FACIL: 50-269 Oconee Nuclear Station, Unit 1, Duke Power Co. 05000269

SUBJECT: Forwards response to request for addl info re GL 87-02, suppl 1, re resolution of USI A-46. D

Re: Oconee Nuclear Station, Units 1, 2, and 3
Docket Nos. 50-269, 50-270, 50-287
License Nos. DPR 38, 47, 55
Response to Supplement 1 to Generic
Letter 87-02 on SQUG Resolution of USI A-46

RESPONSE TO NRC'S REQUEST FOR ADDITIONAL INFORMATION

Scaled El Centro May 1940 Ground Response Spectrum Comparison to Oconee Required Response Spectrum (5% damping)

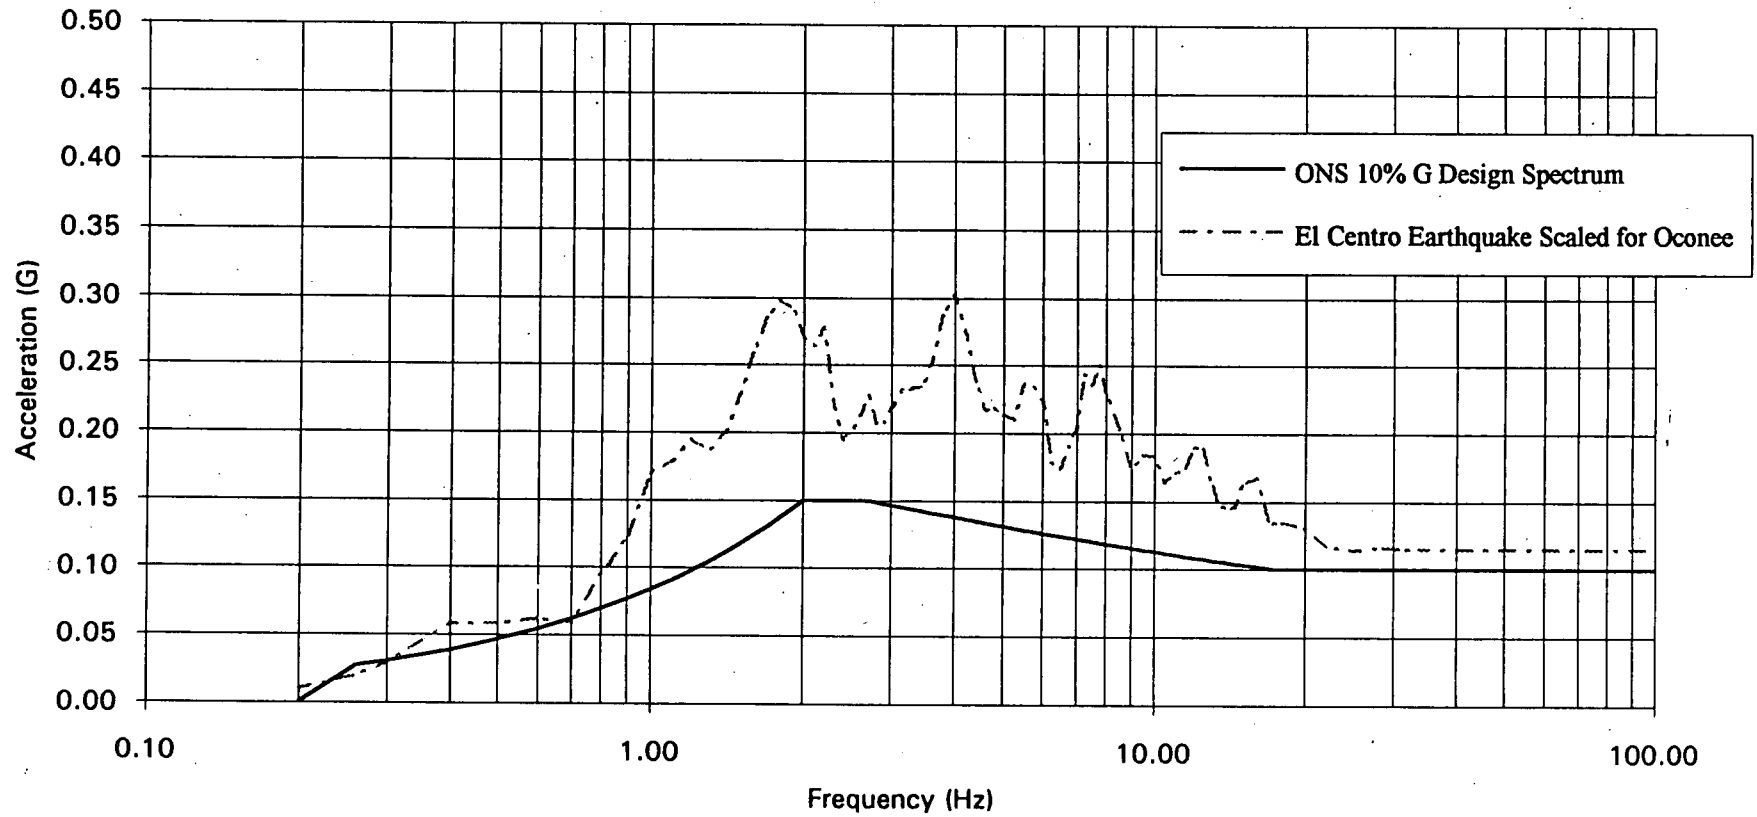
4. Question: Provide a discussion of the conservatism associated with the time history input by comparing its spectra with the original spectra.

Response: A plot of the scaled El Centro time history spectrum used for generation of in-structure spectra compared with the original design spectrum is shown on Attachment 3. The magnitude of the margin between the scaled El Centro Spectrum and the Design Ground Spectrum is a source of significant conservatism in the in-structure response spectra.
